**BELLEFONTE COMBINED LICENSE APPLICATION – RESPONSE TO REQUEST FOR
ADDITIONAL INFORMATION – SHORT TERM ATMOSPHERIC DISPERSION
ESTIMATES FOR ACCIDENT RELEASES**

Subject: Short Term Atmospheric Dispersion Estimates for Accident Releases in the Final Safety
Analysis Report

NRC RAI NUMBER: 02.03.04-05

Figure 02.

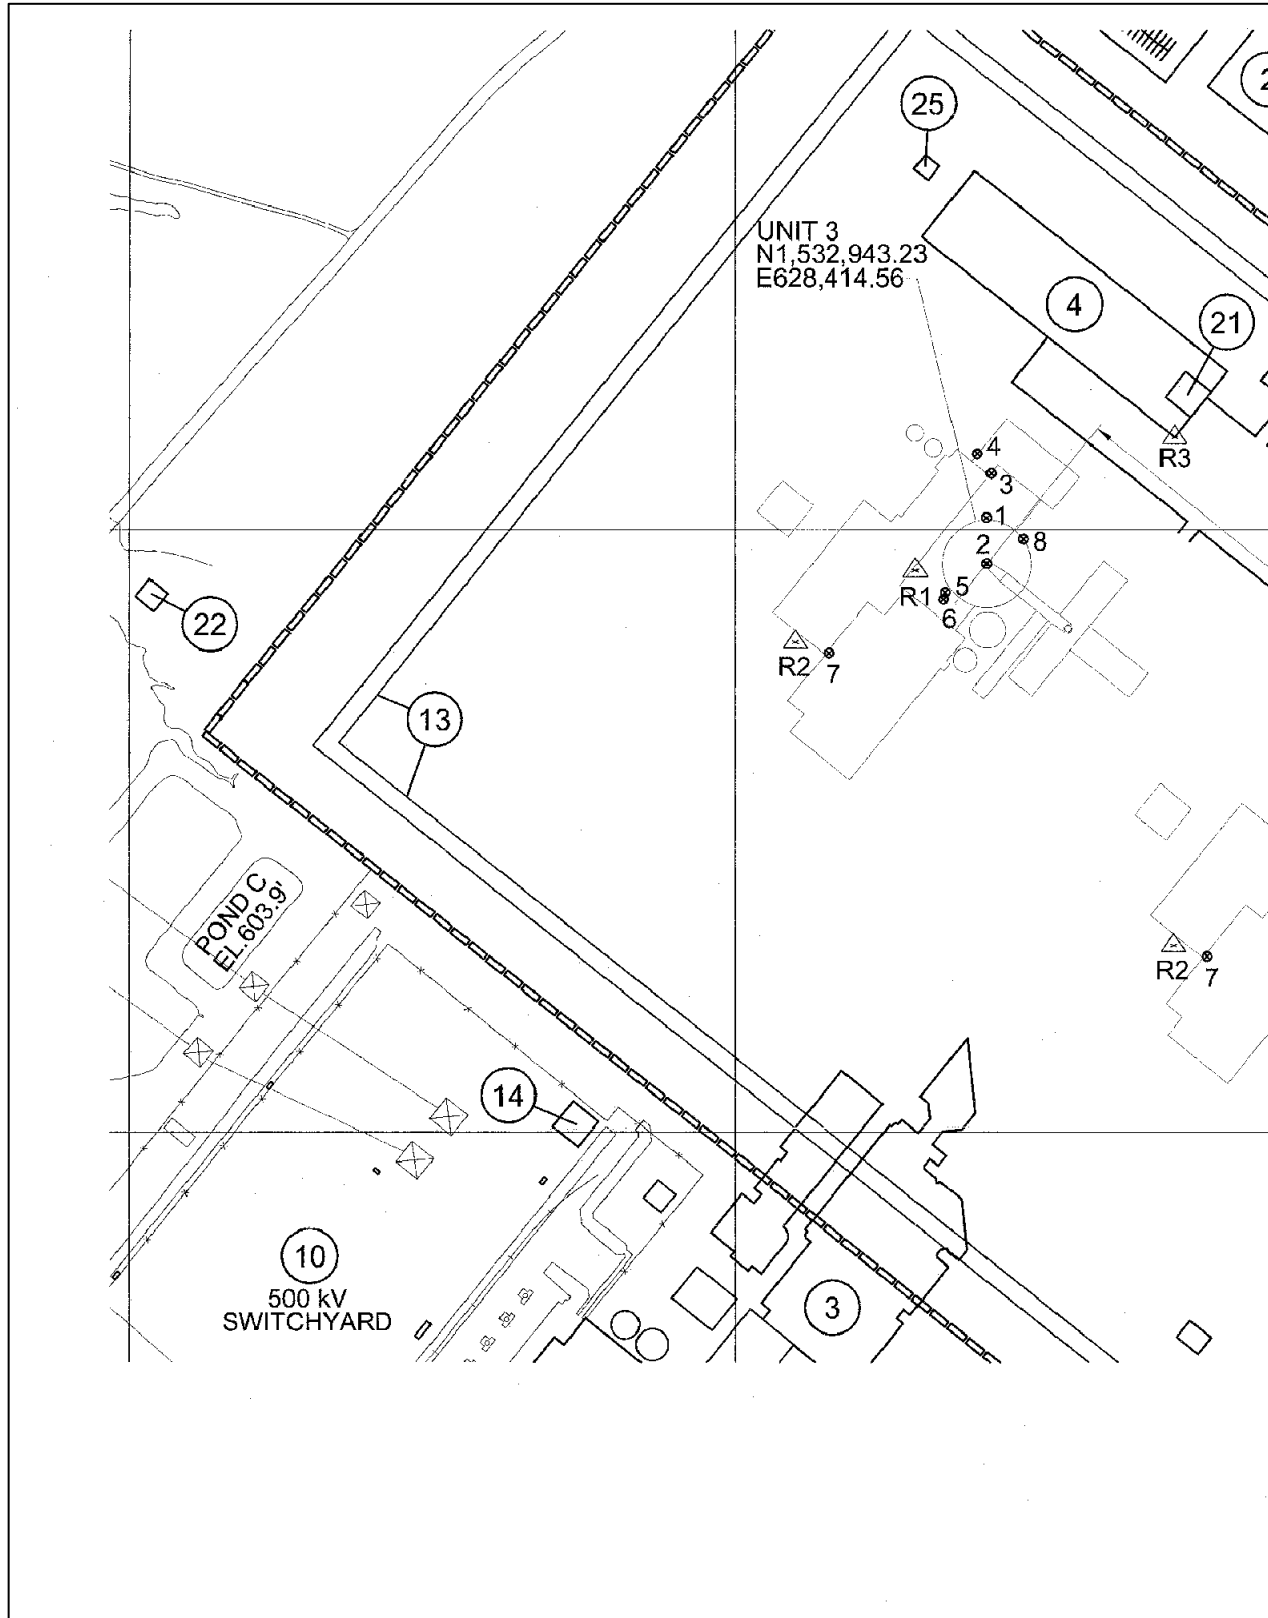
The applicant has taken a departure in FSAR Chapter 18, Human Factors Engineering, in that the Bellefonte TSC is not located in the control building as identified in the AP1000 DCD (Departure No. BNL DEP 18.8-1). Provide a description of the methodology, inputs, assumptions, and calculated atmospheric dispersion factors (χ/Q values) for releases from the Plant Vent, PCS Air Diffuser, Fuel Building Blowout Panel, Fuel Building Rail Bay Door, Steam Vent, PORV/Safety Valves, Condenser Air Removal Stack, and Containment Shell to the Technical Support Center (TSC). Information provided should be analogous to that provided for releases to the control room and include drawings to show relevant information graphically. Consider providing the computer input files as part of the response.

The TSC is located in the east end of the BLN maintenance building as shown in the Site Layout, FSAR Figure 1.1-202. Exact locations of the receptors of interest, the TSC HVAC intake and facility entrance, are not yet final; therefore, they are conservatively assumed to be located on the wall of the new maintenance building closest to Unit 3 at an elevation of 1.5 m (see Figure 02.03.04-05A below).

The AP1000 release locations are given on DCD Figure 15A-1 and Table 15A-7. When these locations are transposed onto the BLN Site Layout as shown in Figure 02.03.04-05A, it can be seen that the general

direction from the assumed TSC receptors to the majority of the release locations is very similar. The release locations that are closest to the TSC are the containment shell, the plant vent, the fuel building blowout panel, and the radwaste building truck staging area door. According to the AP1000 DCD Table 15A-6, the fuel building blowout panel and the radwaste building truck staging area door are release locations associated with spent fuel pool boiling and the fuel handling accident (FHA) occurring outside containment, respectively. Spent fuel pool boiling occurs as a result of loss of spent fuel pool cooling. The 30-day contribution of pool boiling to the dose at the low population zone boundary is less than 0.01 rem TEDE (see DCD Subsection 15.6.5.3). The duration of the FHA is two hours. In addition, the offsite doses are 25 percent or less than the dose guideline of 25 rem TEDE identified in 10 CFR 50.34 (see DCD Subsection 15.7.4.5). The limiting AP1000 offsite radiological consequences are associated with a LOCA with core melt scenario (see DCD Table 15.6.5-3). Therefore, since the distance and direction to the containment shell and plant vent are similar and the release height of the containment shell is lower, the containment shell is the most conservative LOCA release location to consider in the evaluation of TSC atmospheric dispersion values. Therefore, a LOCA release from the containment shell is conservatively assumed.

The containment shell is a diffuse area source. The height and width of the area source are taken as the maximum vertical and horizontal dimensions of the above grade shield building cross-sectional area perpendicular to the line of sight from the building center to the TSC receptor location. The area of the containment obscured by the radwaste and auxiliary building was determined and subtracted from the total projected area of the containment to determine a representative area of the diffuse source, i.e., 36.6 m (120.1 ft) high by 44.2 m (145 ft) wide. The release height is set at the vertical center of the projected plane. The source-to-receptor distance is measured from the shield building to the TSC intake. Based on this approach, the vertical and horizontal diffusion coefficients are determined to be 6.1 m (20.0 ft) and 7.4 m (24.2 ft), respectively. The release height is at elevation 64.7 m (212.3 ft) or 34.2 m (112.3 ft) above grade. The horizontal distance from the projected plane of the Unit 3 containment to the TSC HVAC inlet is 91 m and the horizontal distance from the projected plane of the Unit 4 containment to the TSC HVAC inlet is 224 m as given in Table 02.03.04-05A below.

The direction to the source is used to establish which range of wind directions should be used in the assessment of the χ/Q values. The direction must have the same point of reference as the wind directions reported in the meteorological data; therefore, the directions from the receptors to the sources obtained from the Site Layout, are measured relative to True North. The receptor distances and directions used in this analysis are reported in Table 02.03.04-05A, below.
